QUALITY ASSURANCE -- NON-CONFORMANCE REPORT

Location: Changxing Island, Shanghai, China**Report No:** NCR-000814**Prime Contractor:** American Bridge/Fluor Enterprises, a JV**Date:** 25-Jul-2010**Submitting Contractor:** Zhenhua Port Machinery Company, Ltd (ZPMC), Changxing Island**NCR #:** ZPMC-0776**Type of problem:**

Welding	Concrete	Other	
Welding	Curing	Procedural	Bridge No: 34-0006
Joint fit-up	Coating	Other	Component: Suspender Brackets SB86W & SB78E
Procedural	Procedural	Description: Missed VT indications by QC

Reference Description: Missed Indications and Visual defects discovered after ZPMC had tested and accepted these welds

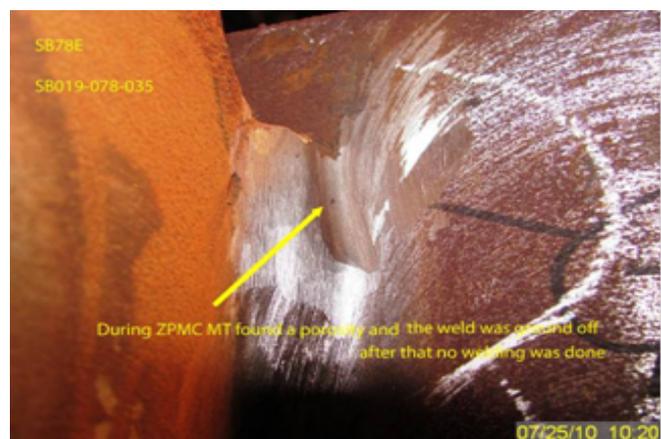
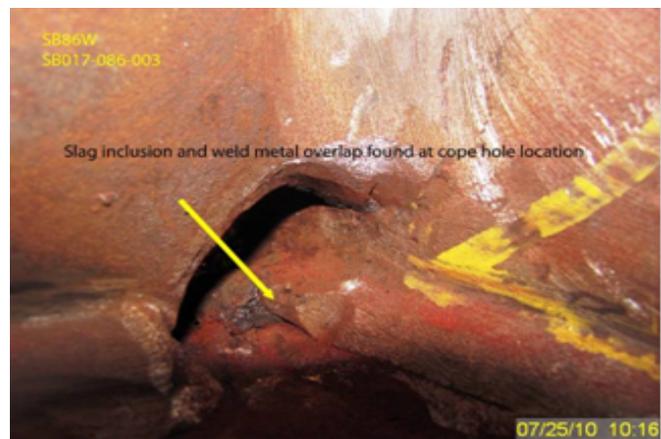
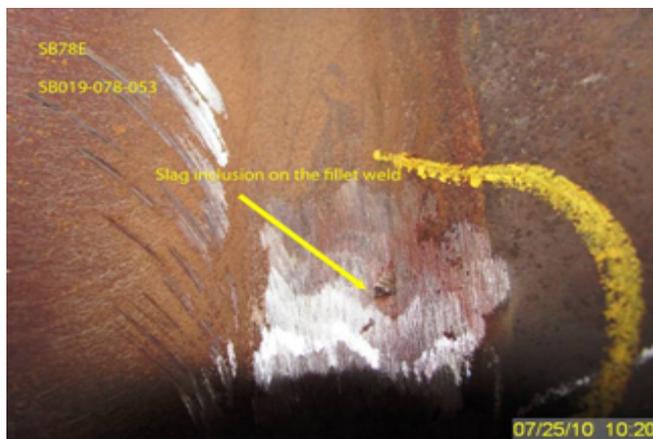
- During MT of the fillet weld, this QA observed 1 linear indication on weld identified as SB017-086-041.
- The indication was ground by ZPMC personnel and a 10mm long slag inclusion was observed near the root of the fillet weld.
- During QA VT of Cope holes, this QA observed slag inclusion, underfill and overlap at weld identified as SB017-086-003.

- During VT of this weld, QA observed an incomplete weld near the cope hole location. The fillet weld is identified as SB019-078-002.
- Arc strike was observed on the weld and base metal. This fillet weld is identified as SB019-078-042.
- An approximately 5mm deep grinding mark observed on a fillet weld identified as SB019-078-035.
- Slag inclusion was observed on a fillet weld identified as SB019-078-053.
- Welds mentioned above are fillet welds connecting the suspender bracket center web plate to the vertical stiffeners.
- The Notice of Witness Inspection Number (NWIT) is 006276.
- The indications and VT issues are clearly marked on the material near the weld.
- The indications and VT issues are located within the area that has been previously tested and accepted by ZPMC Quality Control (QC) personnel.

AWS D1.5 (02) - 6.26.1: Visual Inspection. All welds shall be visually inspected.

AWS D1.5 (02) - 3.7.2.3: Excessive Weld Porosity, Excessive Slag Inclusions, Incomplete Fusion. Unacceptable portions shall be removed and re-welded.

AWS D1.5 (02) - 3.6.5: Welds shall be free from overlap.

Reference Resolution: ZPMC has repaired the areas noted in the NCR and is submitting the VT and MT documents to show that the repair was successful.

This NCR was issued for several nonconforming VT issues on suspender bracket welds including underfill, overlap, incomplete welds, unwelded excavation, slag inclusions and a transverse crack that was removed by grinding and confirmed to be a slag inclusion. A CWR was submitted for the transverse crack, and a VT report noting it was completed after the cover pass saying the rest of the welds are acceptable. However, confirmation is also needed that the other issues were addressed and the VT report was after grinding / repairing the other noted issues.

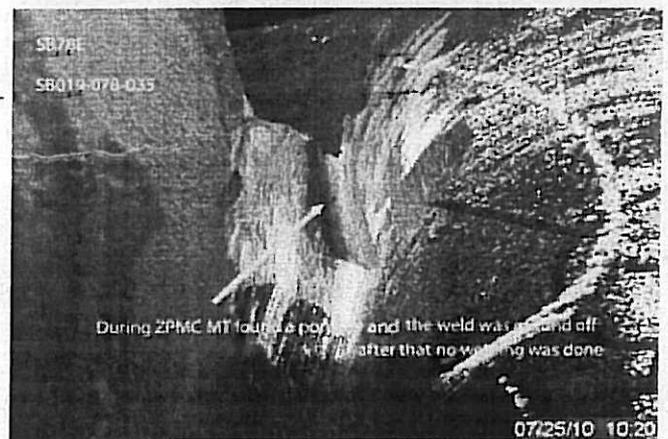
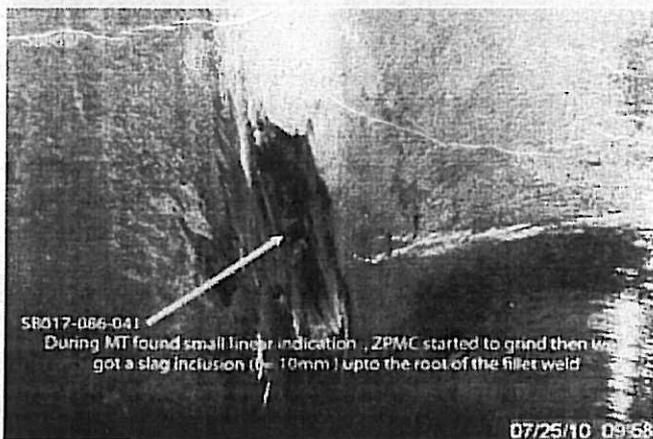
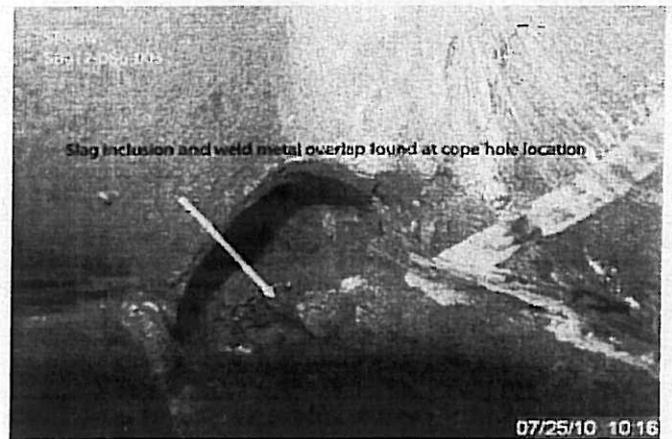
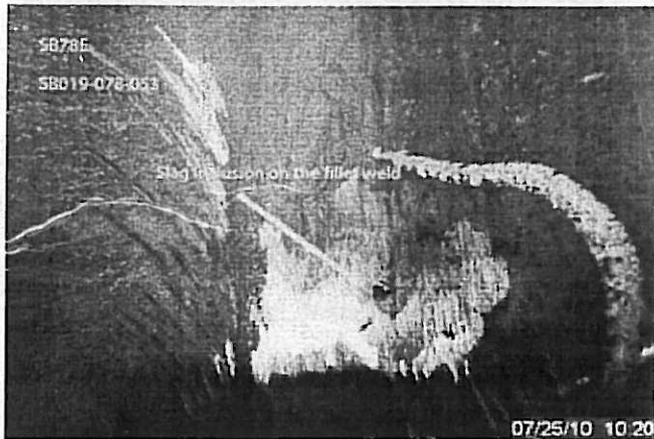
-During MT of the fillet weld, this QA observed 1 linear indication on weld identified as SB017-086-041.

-The indication was ground by ZPMC personnel and a 10mm long slag inclusion was observed near the root of the fillet weld.

-During QA VT of Cope holes, this QA observed slag inclusion, underfill and overlap at weld identified as SB017-086-003.

-During VT of this weld, QA observed an incomplete weld near the cope hole location. The fillet weld is identified as SB019-078-002.

-Arc strike was observed on the weld and base metal. This fillet weld is identified as SB019-078-042.

-An approximately 5mm deep grinding mark observed on a fillet weld identified as SB019-078-035.

-Slag inclusion was observed on a fillet weld identified as SB019-078-053.

-The indications and VT issues are clearly marked on the material near the weld.

Reference Resolution: ZPMC has verified in their letter of response that the noted VT deficiencies have been corrected after repair and grinding.

The proposed resolution is acceptable. This NCR is considered closed.

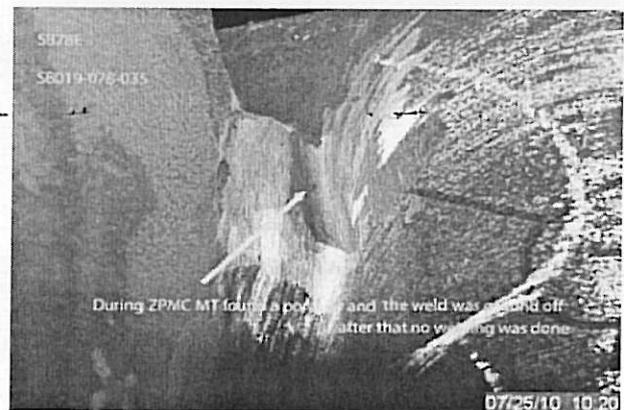
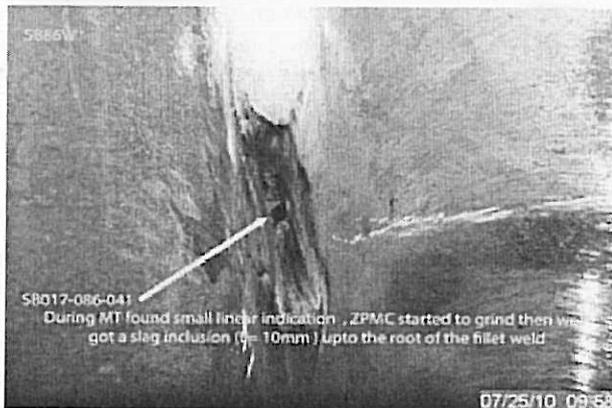
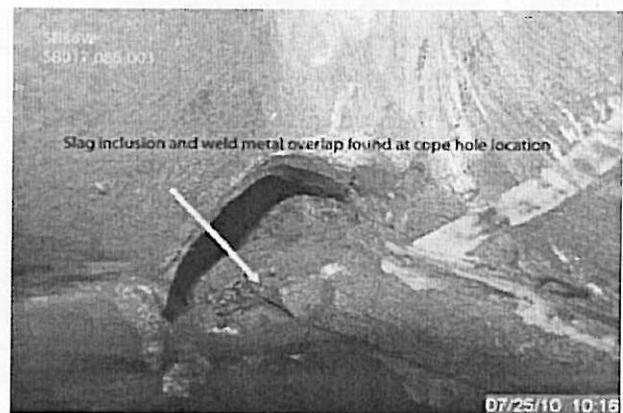
- During MT of the fillet weld, this QA observed 1 linear indication on weld identified as SB017-086-041.
- The indication was ground by ZPMC personnel and a 10mm long slag inclusion was observed near the root of the fillet weld.
- During QA VT of Cope holes, this QA observed slag inclusion, underfill and overlap at weld identified as SB017-086-003.

- During VT of this weld, QA observed an incomplete weld near the cope hole location. The fillet weld is identified as SB019-078-002.
- Arc strike was observed on the weld and base metal. This fillet weld is identified as SB019-078-042.
- An approximately 5mm deep grinding mark observed on a fillet weld identified as SB019-078-035.
- Slag inclusion was observed on a fillet weld identified as SB019-078-053.
- Welds mentioned above are fillet welds connecting the suspender bracket center web plate to the vertical stiffeners.
- The Notice of Witness Inspection Number (NWIT) is 006276.
- The indications and VT issues are clearly marked on the material near the weld.
- The indications and VT issues are located within the area that has been previously tested and accepted by ZPMC Quality Control (QC) personnel.

AWS D1.5 (02) - 3.7.2.3: Excessive Weld Porosity, Excessive Slag Inclusions, Incomplete Fusion. Unacceptable portions shall be removed and re-welded.

- The welds were repaired with VT and MT records for verification.
- ZPMC QA personnel talked with the CWI on the shop floor to prevent future occurrence.
